AGENDA

President and Board of Trustees
Village of Arlington Heights
Board Room

March 6, 2017

- A. Arlington International Racecourse - 2200 W. Euclid Ave. - Sign Variation - DC#16-144
- B. Arlington Heights Police Station - 200 E. Sigwalt St. - PC#16-024 Amendment to PUD Ordinances 05-041 and 78-026

1/30/2017 2:56:12 PM
 WE | 2030 | Engineering | Plots | Preliminary | C101 - Overall Site Plan alt

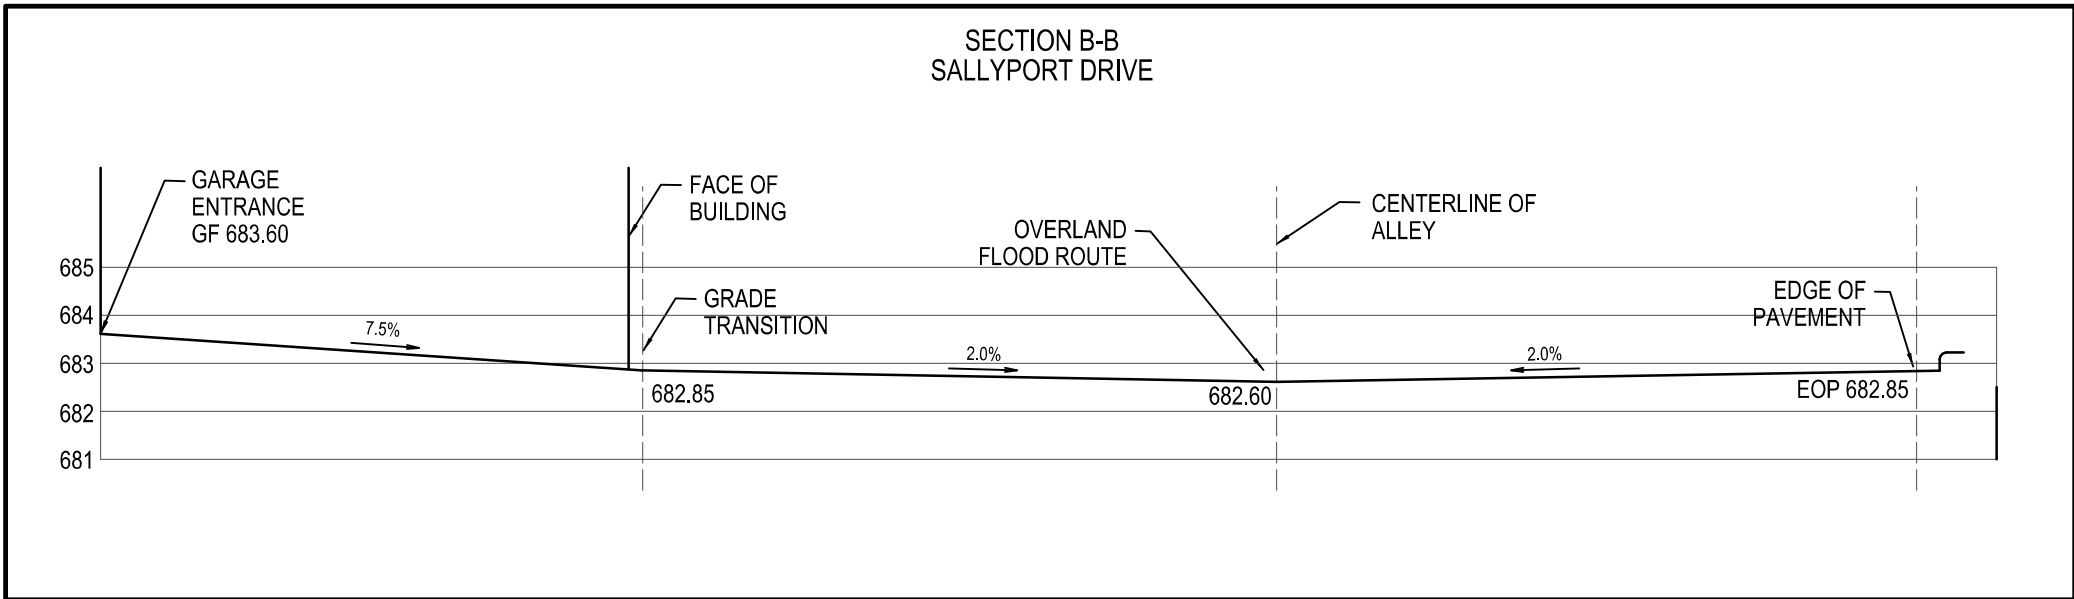
- COMMENT 21:** Sheet C-101: The west driveway shows a through-left lane and a dedicated right turn lane. The traffic report indicates that a single right-thru-left outbound lane will be sufficient, allowing the loading zone to remain. Please show the proper striping/lane usage.

11. Please revise sheet C-101 to indicate the setback distance from the northeast corner of the proposed building to the northern property line.

- RESPONSE 21:** Lane symbols and striping have been revised for the west driveway per conversation with the Village and recommendations of the traffic report. The outbound traffic movements have been revised to a single right-left outbound lane. Please refer to the Preliminary Paving Plan (Sheet C-104).

The distance from the northeast corner of the proposed Police Station building to the northern property line is 30-feet. This dimension has been added to the Preliminary Overall Site Plan (Sheet C-101).

1/10/2017 11:55:15 AM
11/12/2017 Engineering Photo Preliminary C102 - Grading Plan

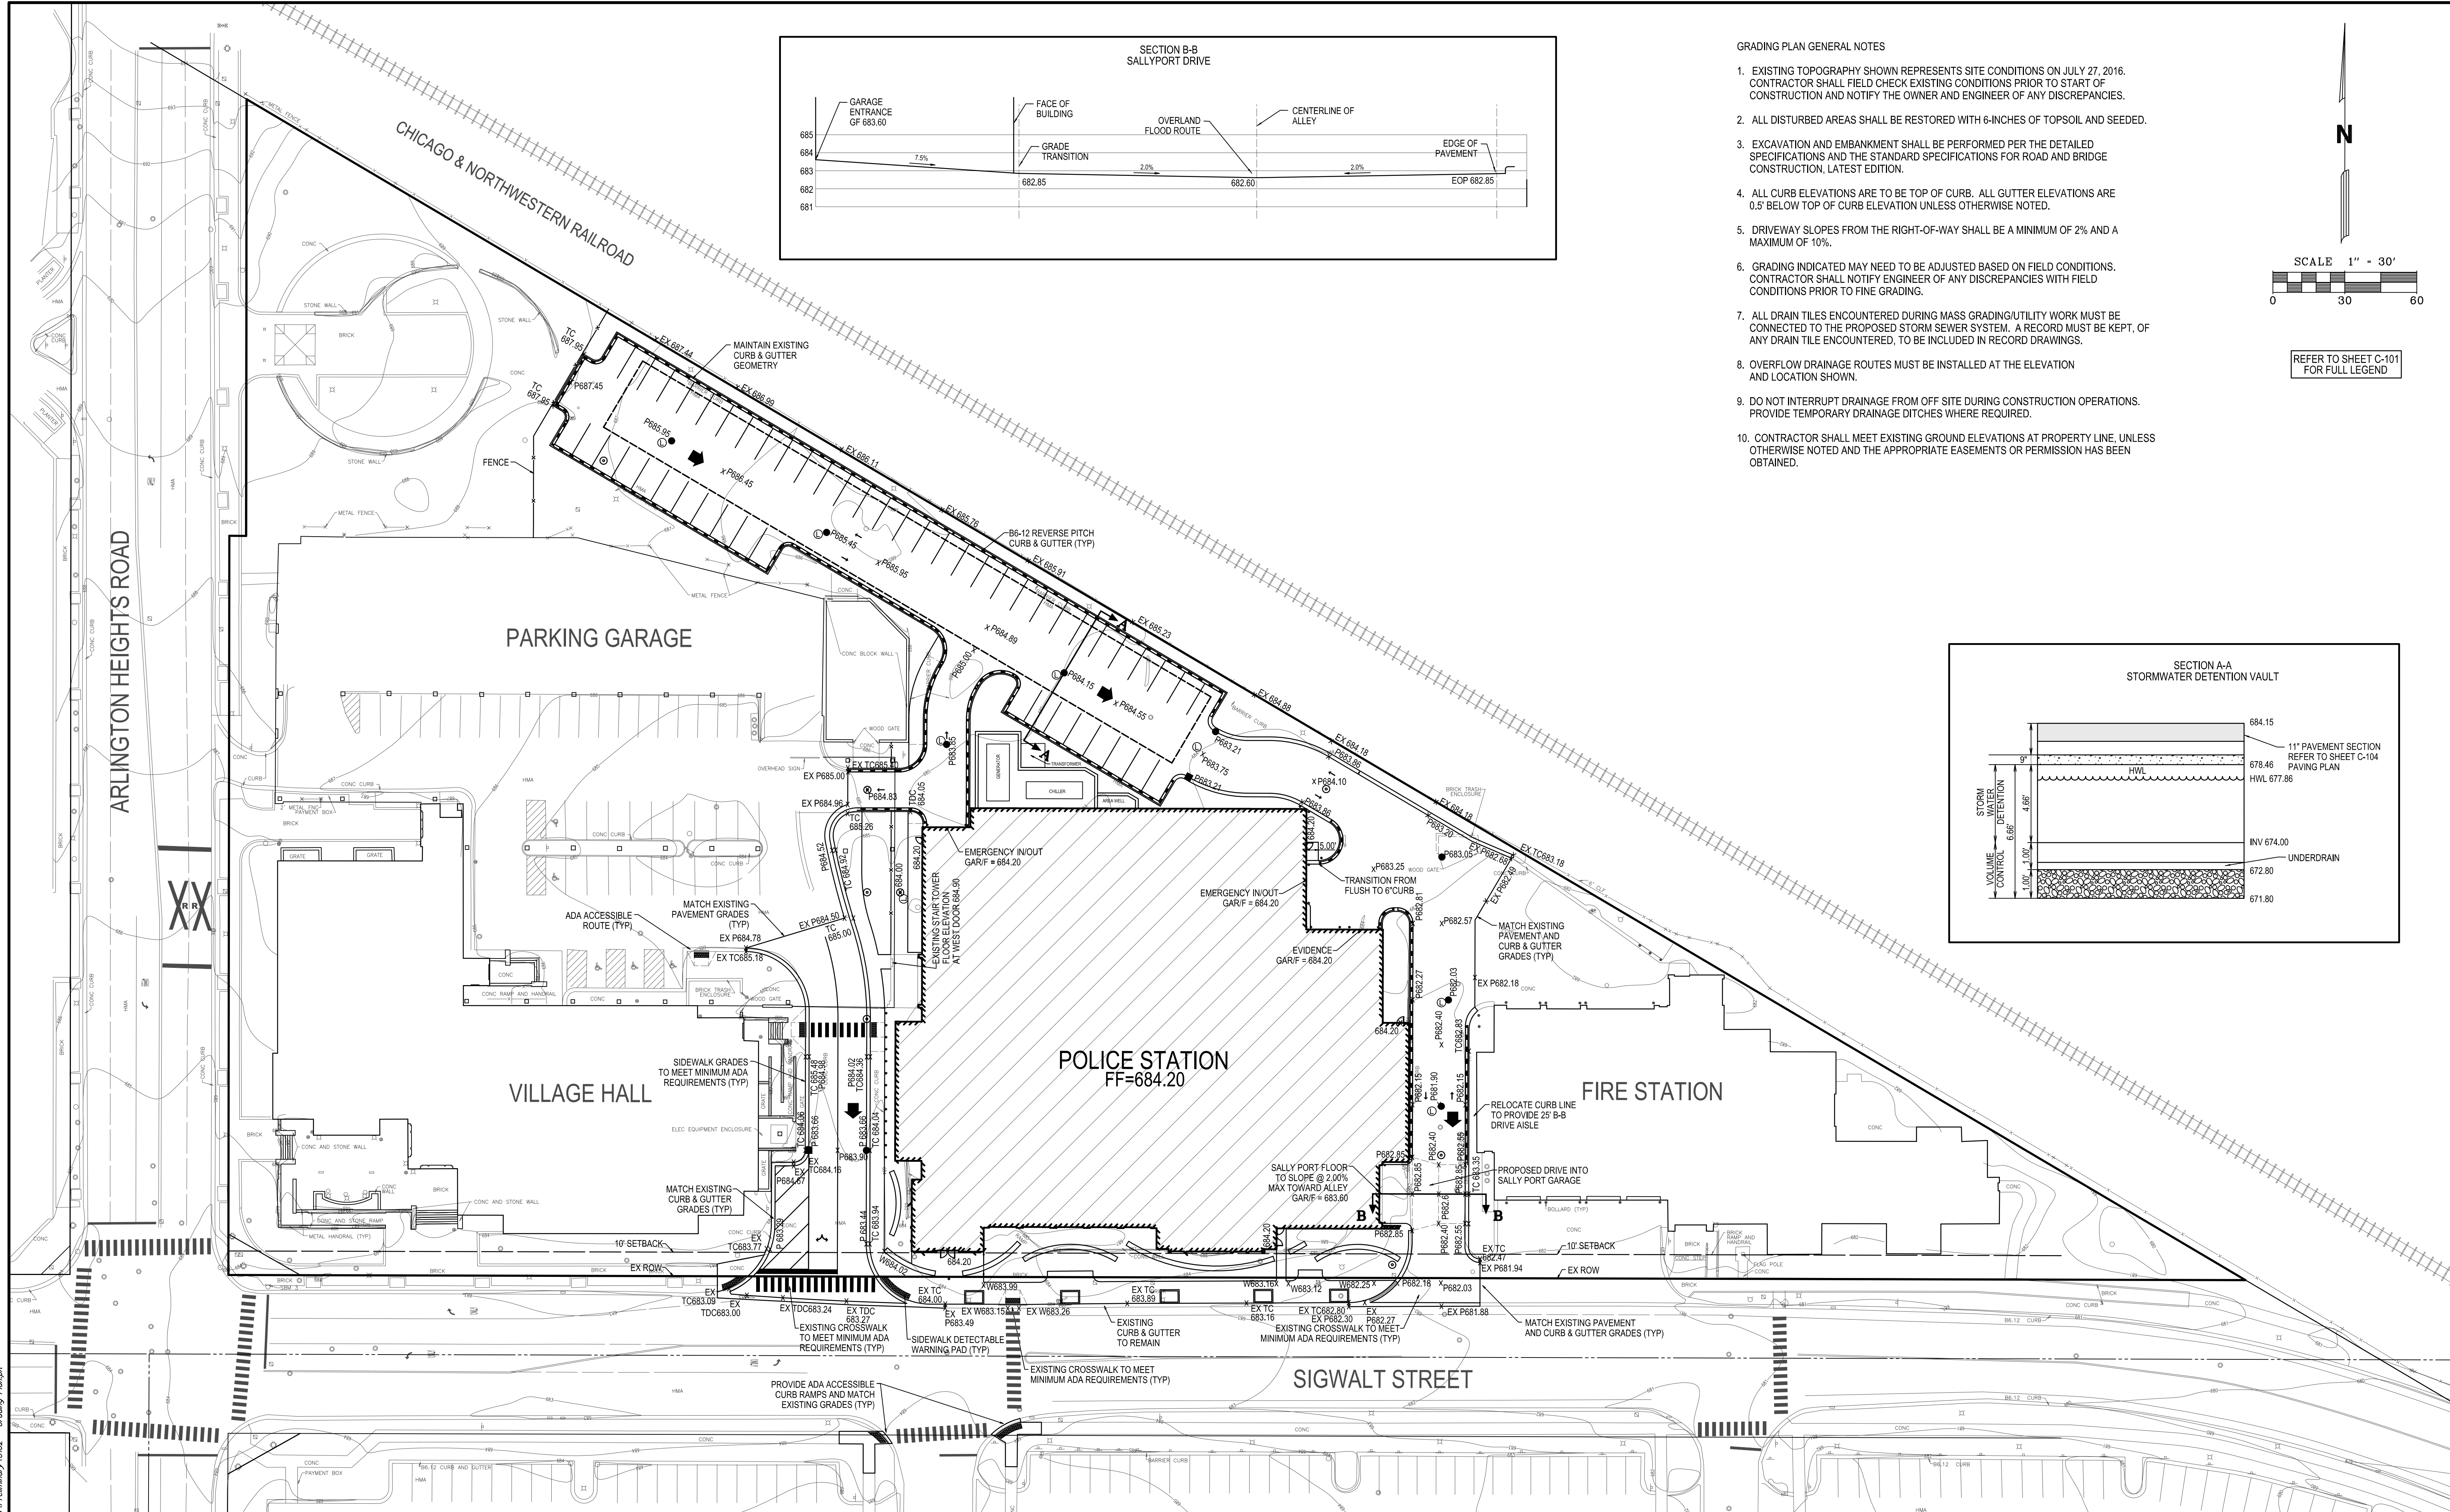
22. Sheet C-102: Can the interior floor of the Sally Port be lowered or sloped to reduce or eliminate the proposed exterior driveway modifications at the door? The building's finished floor elevation is shown at 684.20 and the garage floor elevation at the Sally Port door is the same.

23. Sheet C-102: Clearly show the overflow route for surface water. Ensure via weir calculations that the proposed modifications to the driveway in front of the Sally Port do not impede any overflow.

- COMMENT 22:** Sheet C-102: Can the interior floor of the Sally Port be lowered or sloped to reduce or eliminate the proposed exterior driveway modifications at the door? The building's finished floor elevation is shown at 684.20 and the garage floor elevation at the Sally Port door is the same.

- COMMENT 23:** Sheet C-102: Clearly show the overflow route for surface water. Ensure via weir calculations that the proposed modifications to the driveway in front of the Sally Port do not impede any overflow.

50. The response made by the petitioner to comment #23 is noted. The revised Preliminary Stormwater Management Calculations do not address this comment. The overflow elevation of 682.60 shown on Section B-B on Sheet C-102 is higher than the matching pavement elevations for the existing fire station back driveway. Show the finished floor elevation of the fire station to verify that the overflow does not enter the fire station. The 682.60 overflow elevation is for the pavement. The water would have to build up even higher to flow over this elevation. Depending on area elevations, the overflow may actually be directed toward the railroad ROW and along the north side of the fire station. Need to verify. Note: Isn't TR-20 meant to be used for watershed areas, not small developments of a couple acres?

- RESPONSE 22:** At the request of the Arlington Heights Police Department, the sally port finish floor elevation has been proposed at the same finish floor elevation of the building interior. This is in an effort to ease the transfer of perpetrator from the sally port into the police station. Per discussion with the Village, the sally port garage floor has been revised to pitch toward the alley to reduce the cross slope of the proposed alley. Alley thru traffic will benefit from the reduced cross slope. Refer to the Preliminary Grading Plan (Sheet C-102).

- RESPONSE 23:** The proposed overflow route for surface water has been added to the Preliminary Engineering Plans with critical cross-section and weir calculations. Please refer to the Preliminary Grading Plan (Sheet C-102) and Preliminary Stormwater Calculations.

PRELIMINARY PAVING PLAN
ARLINGTON HEIGHTS POLICE STATION
ARLINGTON HEIGHTS, ILLINOIS

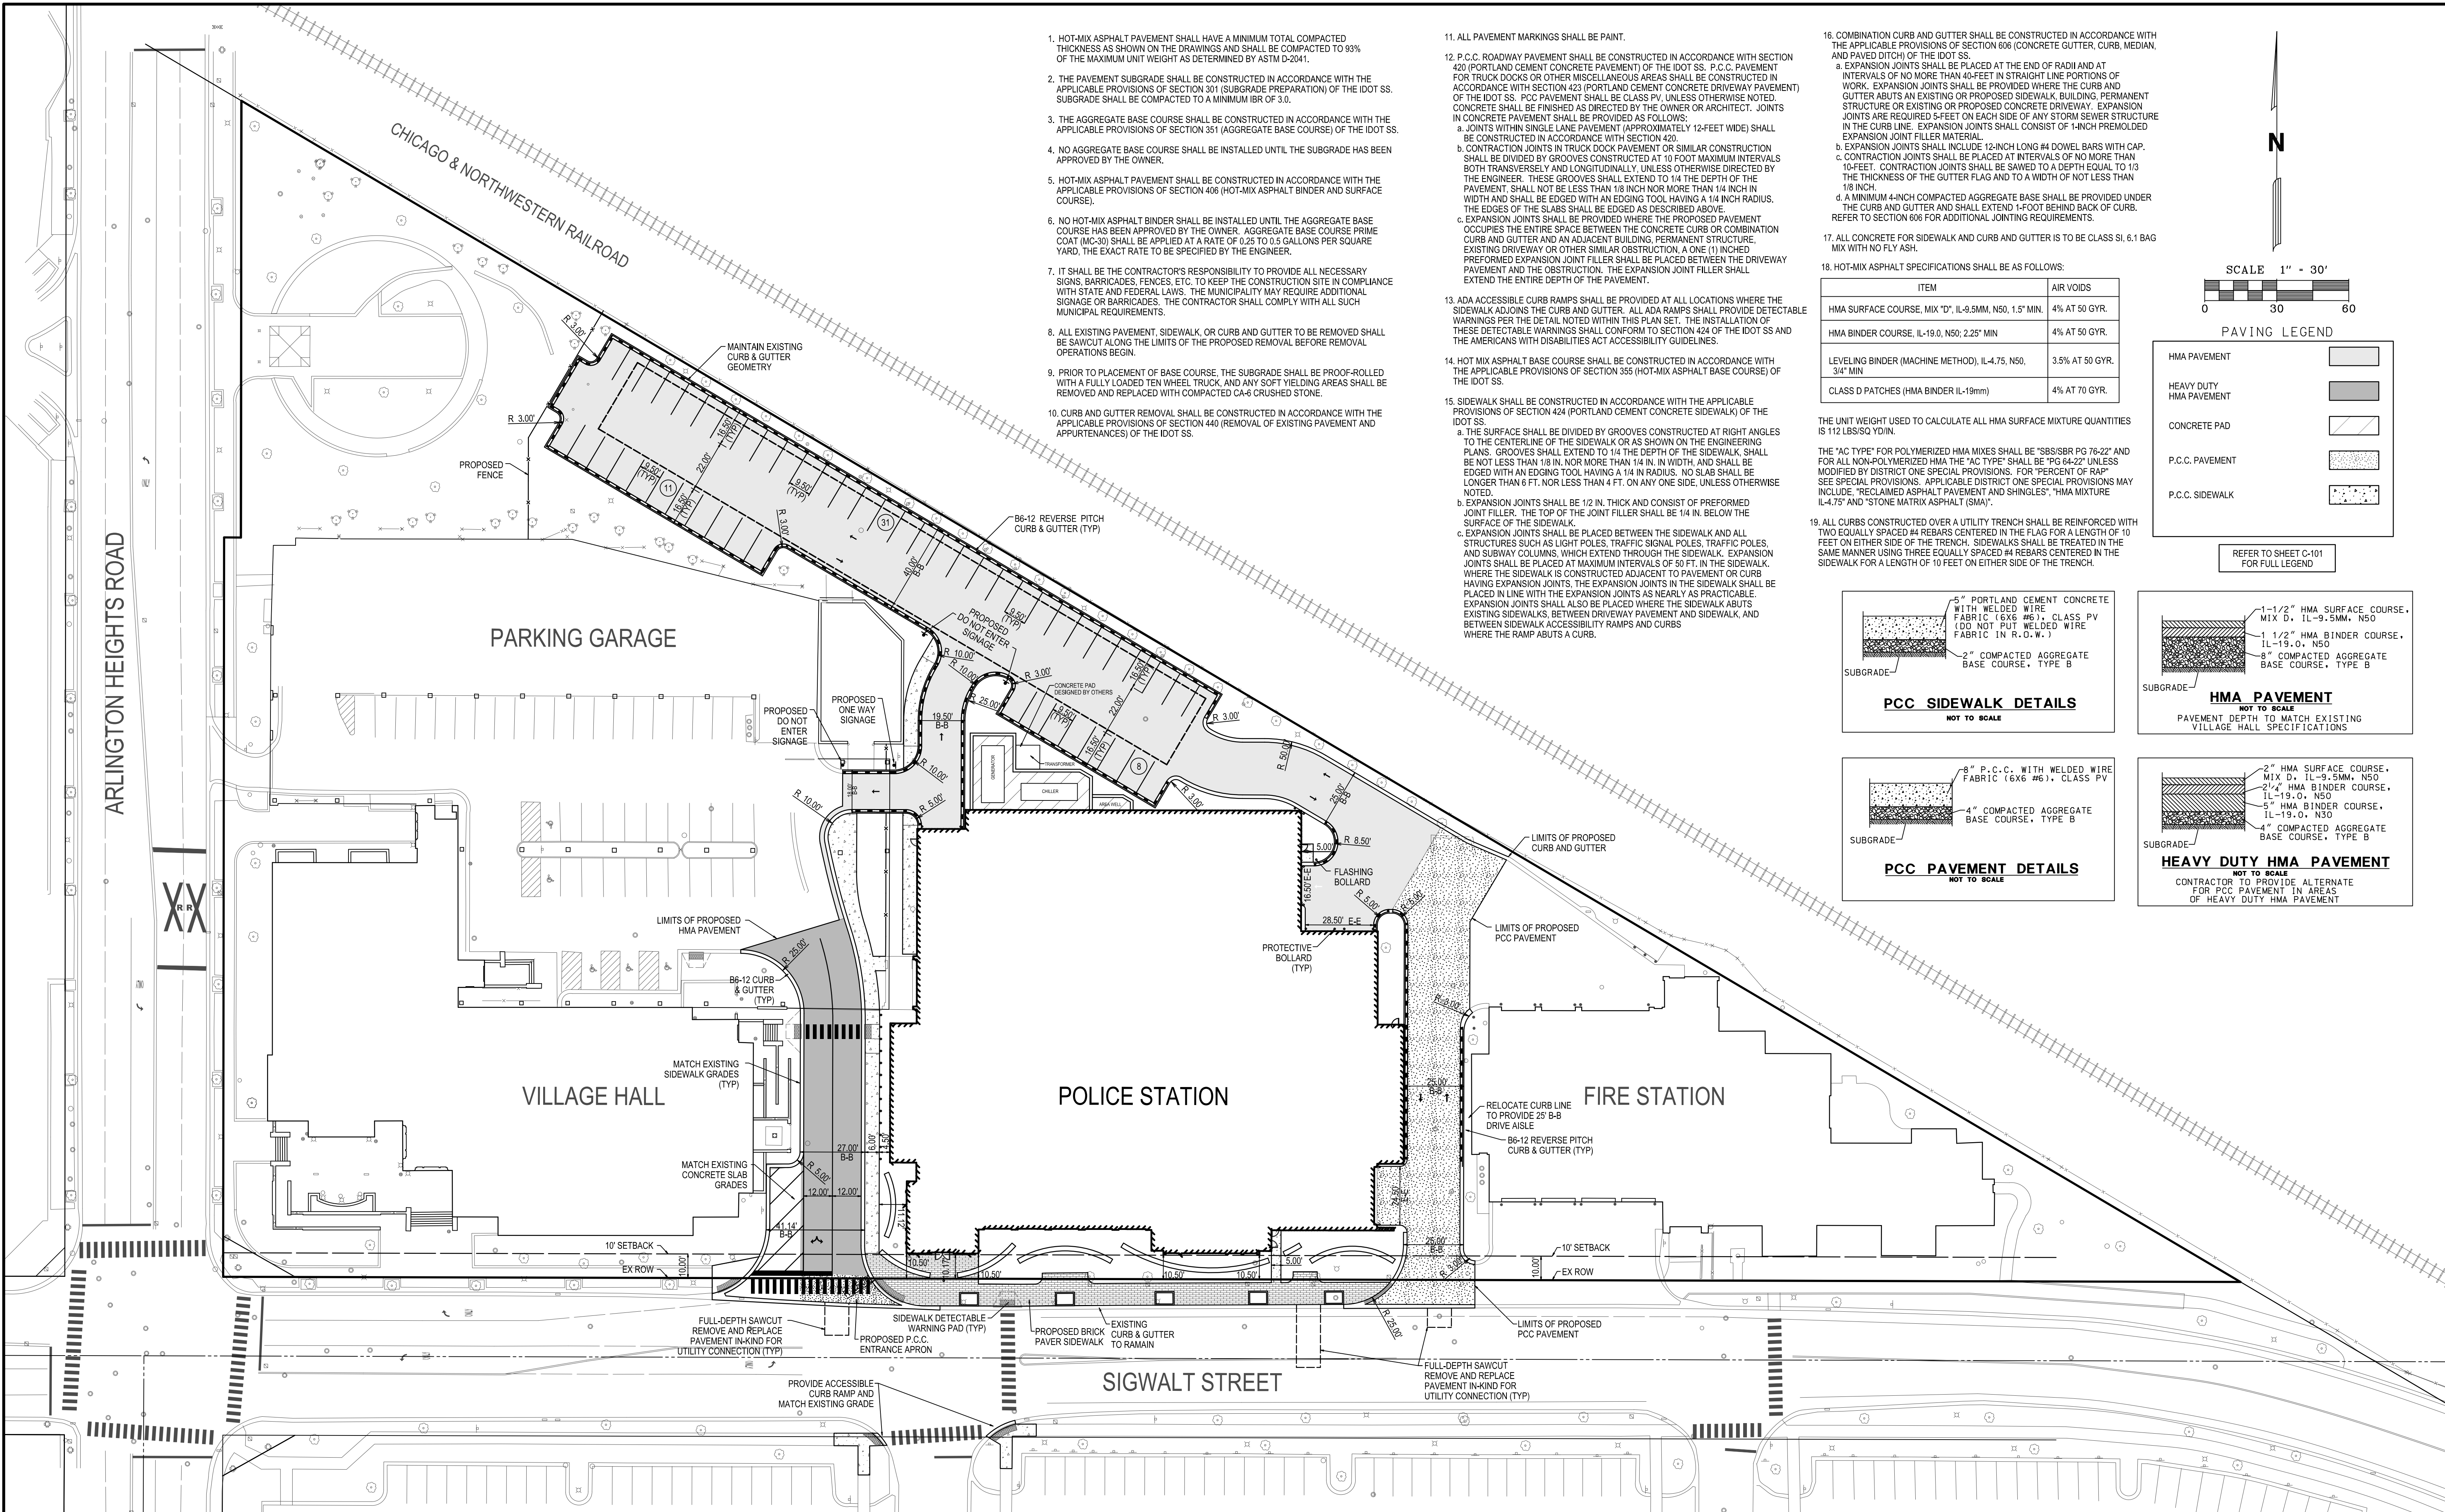
- COMMENT 27:** Sheet C-104: Heavy duty asphalt pavement section to consist of: 2" Surface, 2-1/4" N-50 Binder, 5" N-30 Binder, and 4" CA-6 Stone Subbase.

- COMMENT 28:** Sheet C-104: Based on the pavement widths and the arrows, it appears the drive aisles at the northwest corner of the new building are one-way away from the building. Please confirm this and include the appropriate signage and pavement striping on the final design.

51. The response made by the petitioner to comment #27 is noted. Sheet C-104: The PCC pavement section shall match the recently completed Fire Station 4 concrete driveway pavement section: 10" PCC Concrete, 4" CA-6 Stone Subbase, transverse 1-1/2" dowel bars, longitudinal #6 tie bars. See attached detail.

- RESPONSE 27:** The Heavy Duty asphalt pavement section has been revised to match the above specifications. Please refer to the Preliminary Paving Plan (Sheet C-104).

- RESPONSE 28:** The proposed traffic circulation for the development is such that vehicle movements will be one-way from the proposed parking garage to the north and west. Proposed signage and pavement striping has been included on the plan. Please refer to the Preliminary Paving Plan (Sheet C-104).

Signage for one-way aisles (including "Do Not Enter" signs) have been added to the Preliminary Paving Plan (Sheet C-104).
